UNITED STATES PATENT AND TRADEMARK OFFICE

Office Action Summary

10/718,514

DETAILED ACTION

Fig. 2

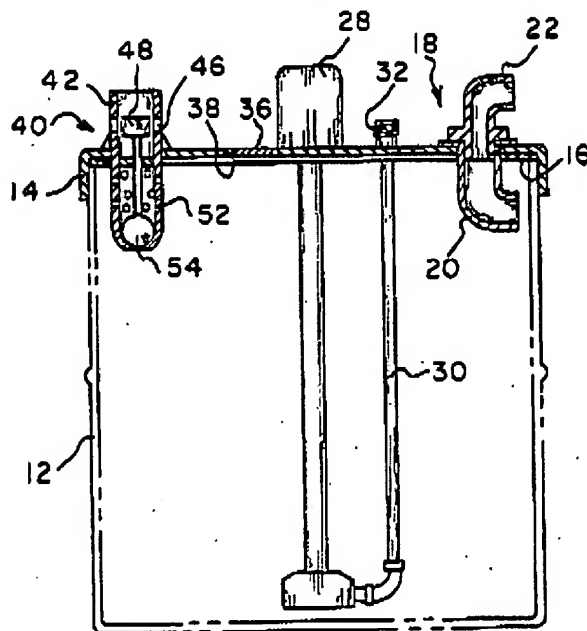
Hallsworth teaches a check valve (48) for a canister (12) capable of receiving fluids, said canister (12) having a vacuum port (40) capable of applying vacuum to said canister (12) for inducing a flow of fluids into said canister (12), said check valve (48) being operably coupled to said vacuum port (40) for stopping said application of vacuum to said canister (12) when said fluids in said canister (12) reach a pre-determined upper level, said check valve (48) comprising:

(a) a floatball (54);

(b) a cage (50, 52) for housing said floatball (54);

(c) a needle valve (56, 48);

(d) a needle valve guide (62) for slidably retaining said needle valve (56, 48), said floatball (54) being positioned below said needle valve (56, 48) to engage said needle valve (56, 48) and lift said needle valve (56, 48) upwardly to effectively stop the vacuum

applied to the vacuum port (40) when said fluids reach said upper level (col. 3, lines 22-64)(see figure 2, *infra*).

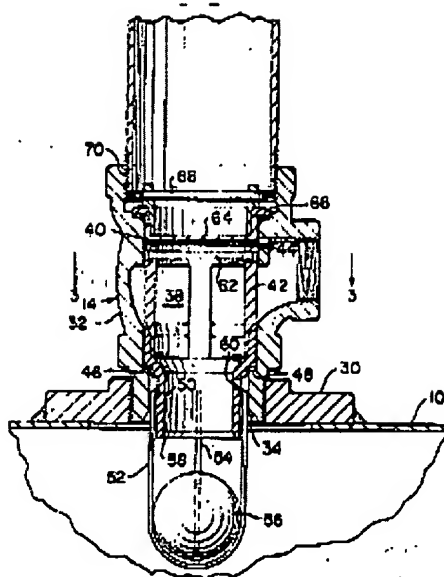
Hallsworth does not teach that the cage comprises a plurality of spaced-apart members.

Smallwood teaches a floatball (56) disposed within a cage comprising a plurality of spaced-apart members (52, 54)(see figure 2, *infra*).

At the time of the invention, it would have been obvious to one of ordinary skill in the art to use the floatball cage construction of Smallwood as the cage in Hallsworth in order to provide a cage that is known in the art to be suitable for that purpose.

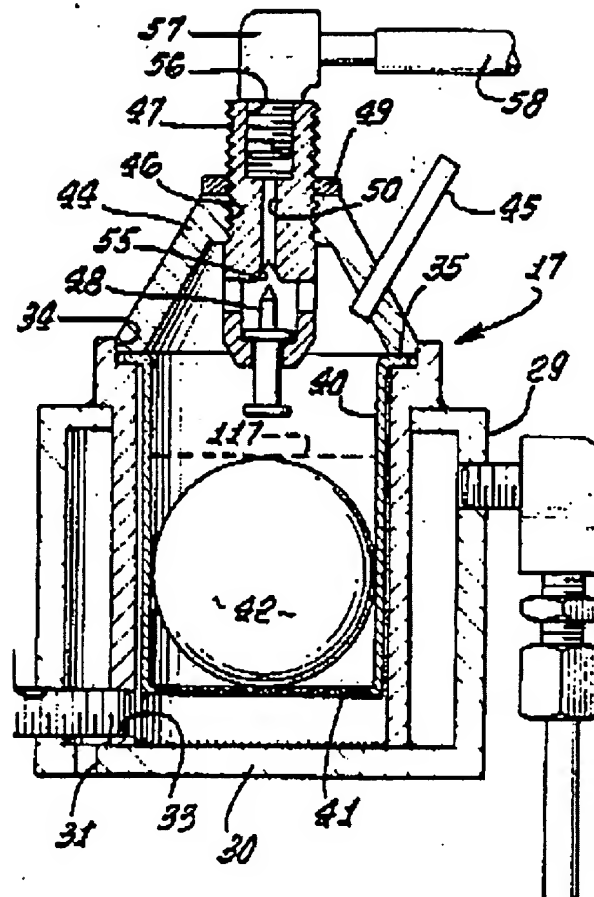
Hallsworth and Smallwood do not teach a needle valve that is detached from the floatball.

Collins teaches a floatball (42) and needle valve (48) that are detached when the valve is open (see figure 4, *infra*). Using separated needle and floatball structures allows them to be manufactured separately and cleaned, replaced or repaired independently of one another.

Making what is known in the art to be integral, separable, is not sufficient to patentably distinguish an invention over the prior art if it is desirable for any reason to make that structure separable. MPEP § 2144.04.
